**ARCHITECTURAL REVIEW BOARD
MUNICIPAL PLANNING COMMISSION
-AGENDA-
Thursday, May 28, 2026 at 7:00 P.M.**

1. **Rezoning** – PUD Preliminary Plan – **445 E. Granville Rd.** (Elford Development/Boundless) **PUD 01-2026**

SUBJECT: Staff Memo for the Meeting of May 28, 2026

1. **Rezoning** – PUD Preliminary Plan – **445 E. Granville Rd.** (Elford Development/Boundless)
PUD 01-2026

Sheet #
L2.1

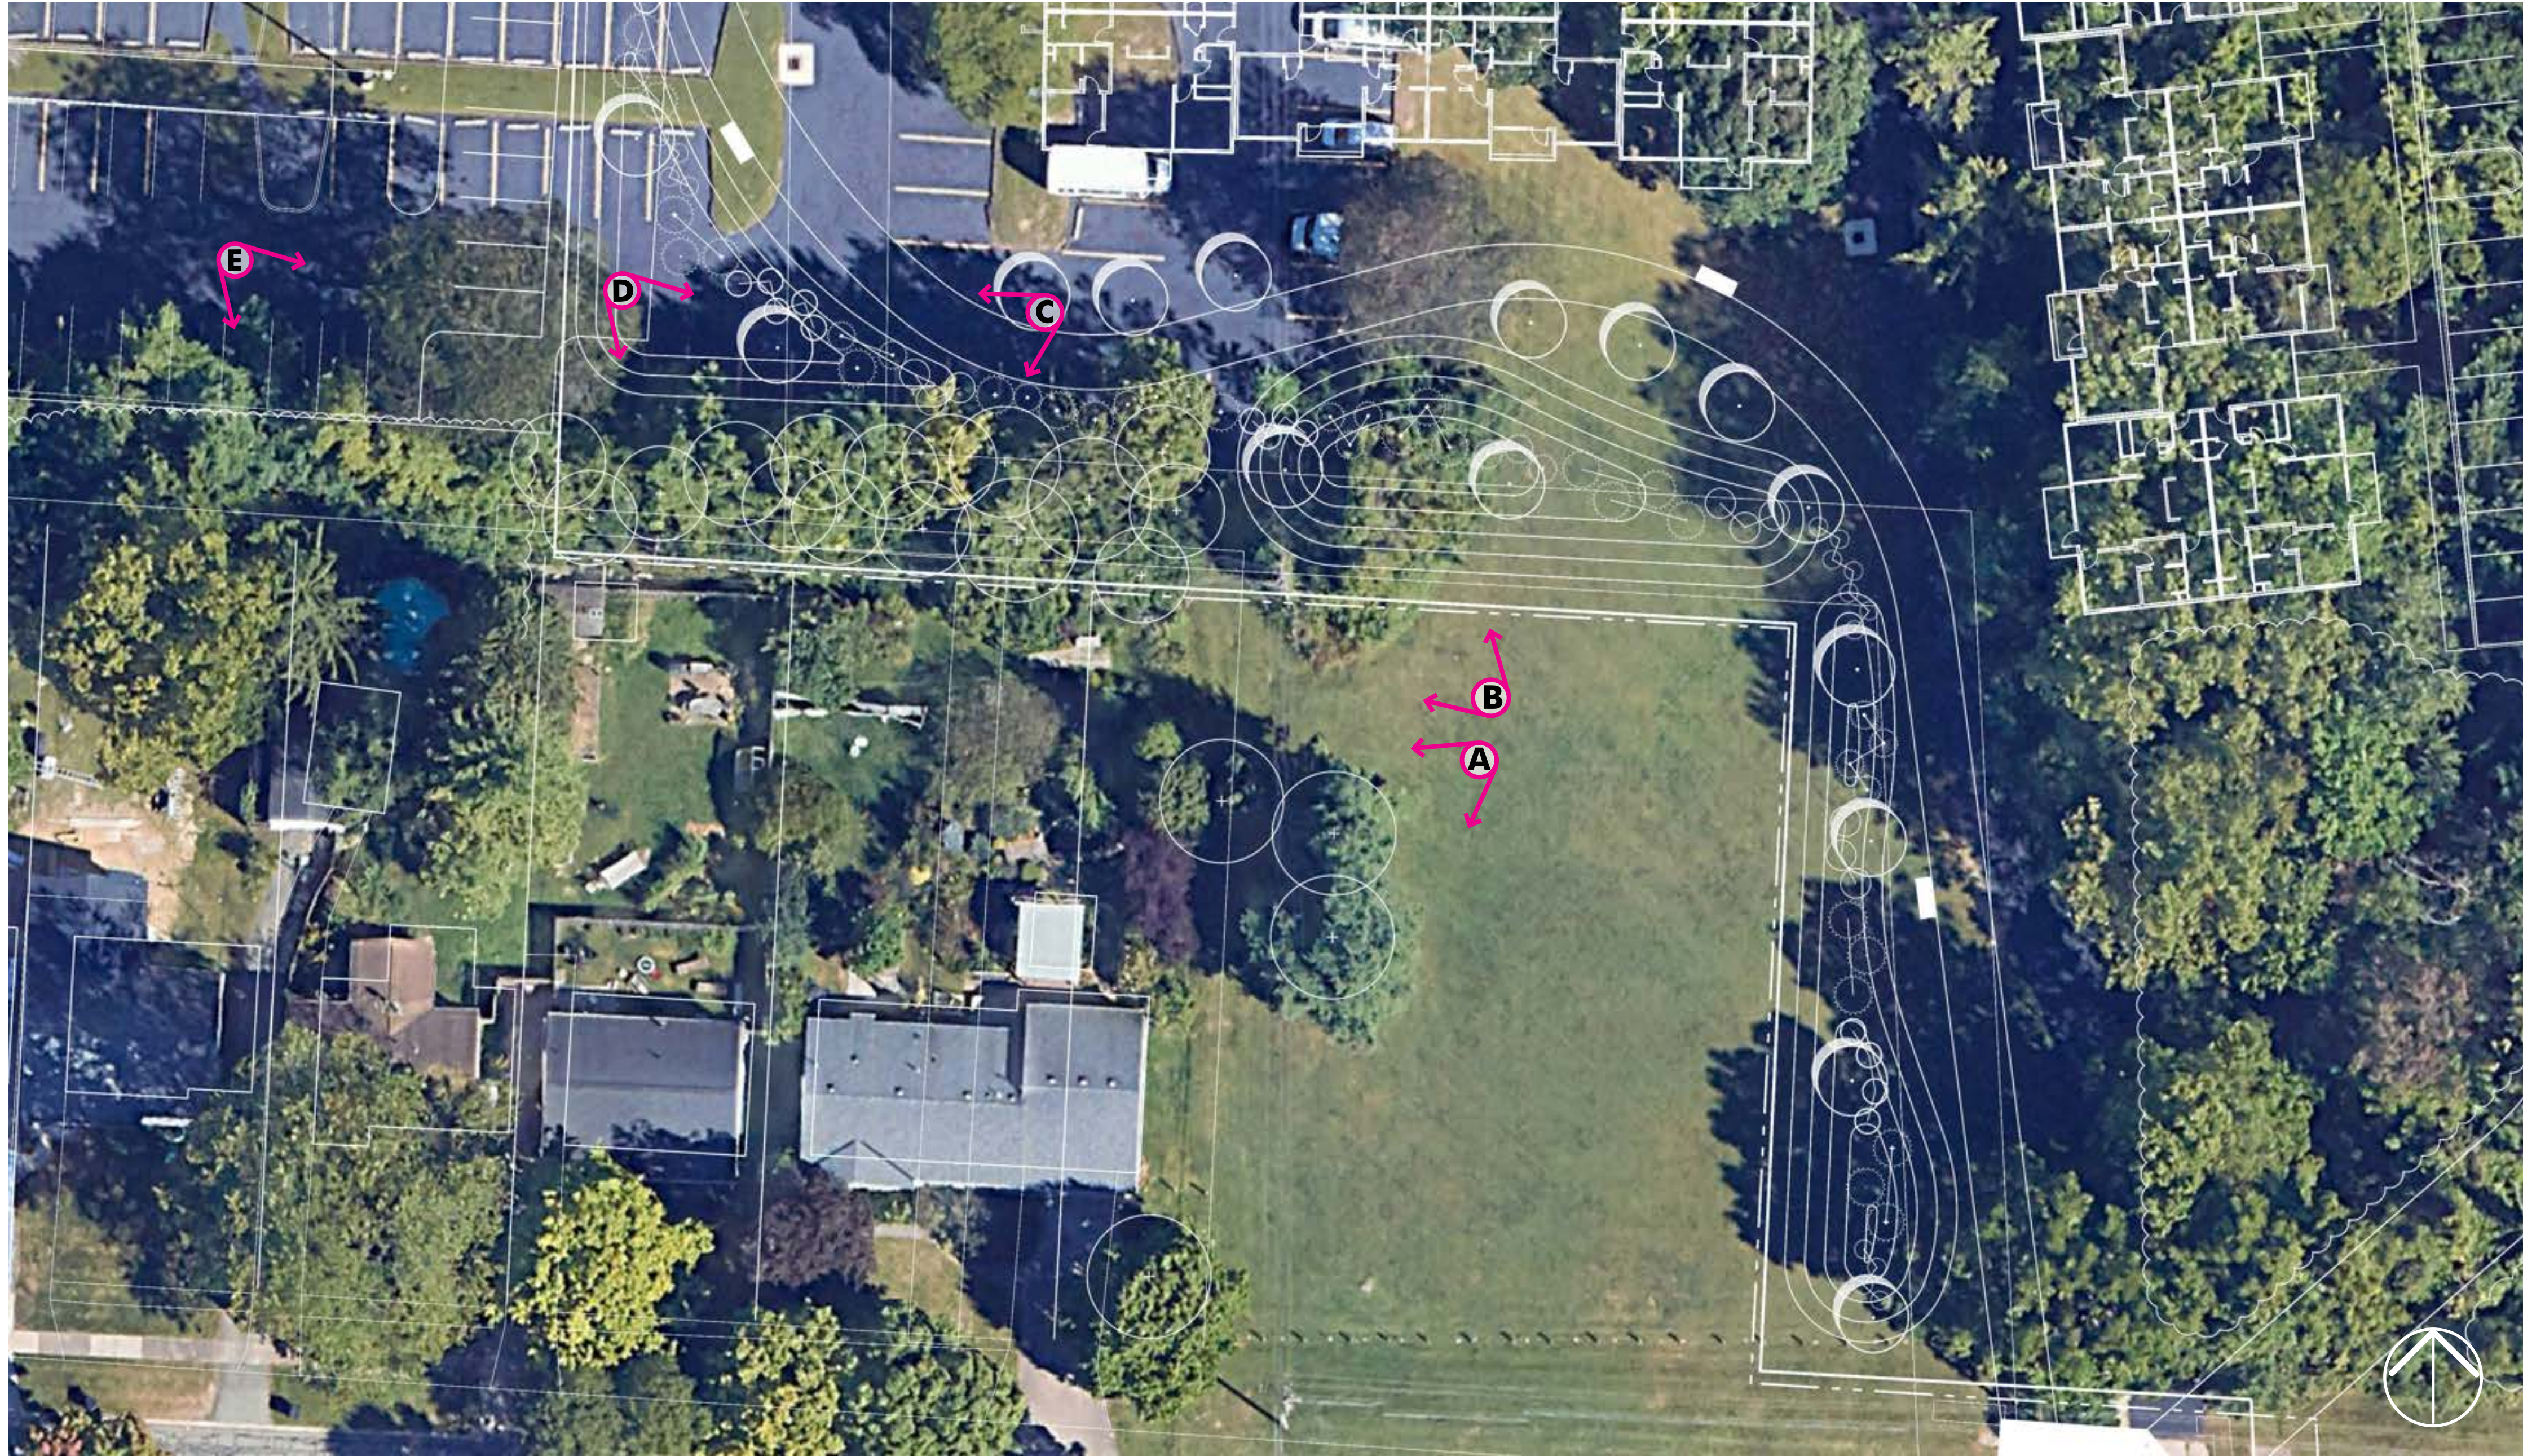
- 3) **L2.1 – South Property Line Planting Plan included**
 - **Mounding shown**
 - **New deciduous and evergreen trees and shrubs planned**
 - **Leave healthy trees**

- **Remove existing invasive plants**
 - **Typical foundation plantings shown**
- d. Lighting
- Lighting plan needed with Final Plan

- The addition of two single-family lots on Park Overlook Dr. should also help reduce the impact of the development.
- **L2.1 – South Property Line Planting Plan would add additional screening of the buildings from Park Overlook Dr.**
